**TOWN OF WEDDINGTON
REGULAR PLANNING BOARD MEETING
TUESDAY, MAY 26, 2026 – 7:00 P.M.
WEDDINGTON TOWN HALL
1924 WEDDINGTON ROAD
WEDDINGTON, NC 28104
AGENDA**

TO: Planning Board
FROM: Town Staff
DATE: May 26, 2026
SUBJECT: Application by Toll Brothers requesting Conditional Zoning approval for a 39-lot Conventional subdivision located on Weddington-Matthews Rd.

APPENDIX 2B 30% SET for **MORRIS FARM**

OVERALL GRADING PLAN

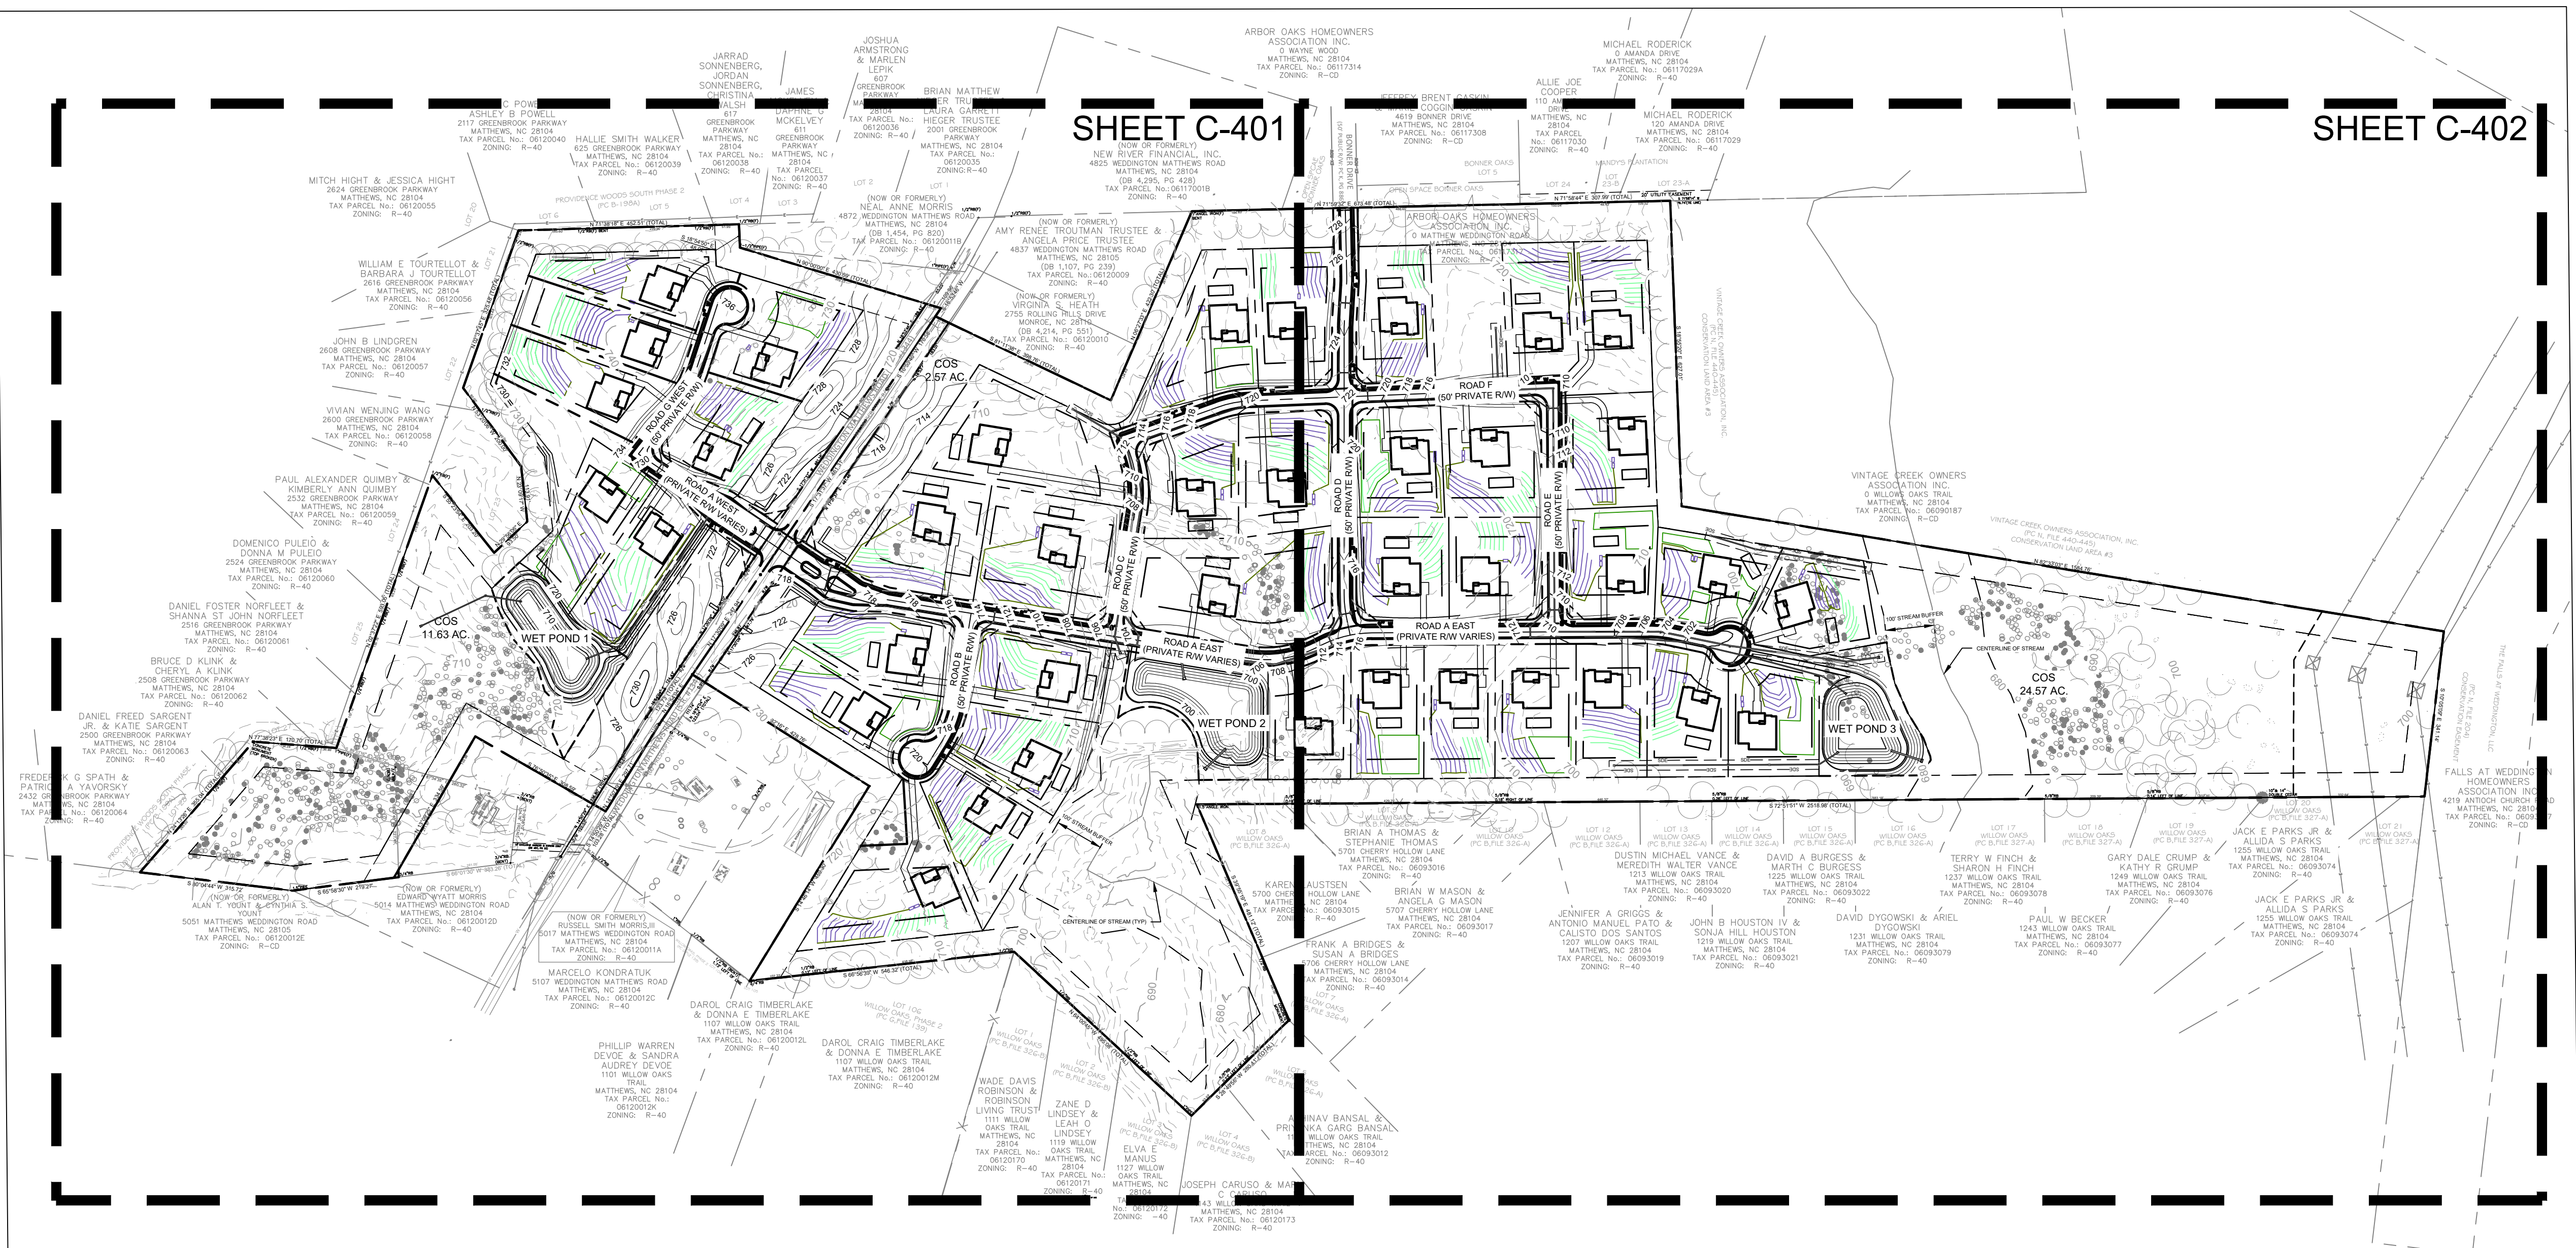
The existing pond (to be removed) and eastern stream drain south towards to the Oliver Creek and Weddington Creek watersheds. The current Schematic Plan no longer crosses these streams and land disturbance is limited 100' to centerline as well as Town sediment control standards. Per the developer, grading shall be performed in separate phases: one for road infrastructure and stormwater ponds, the other for house pads. Mass-clearing is not permitted and would not adhere to the new tree protection standards of Section D-917(A)(Q).
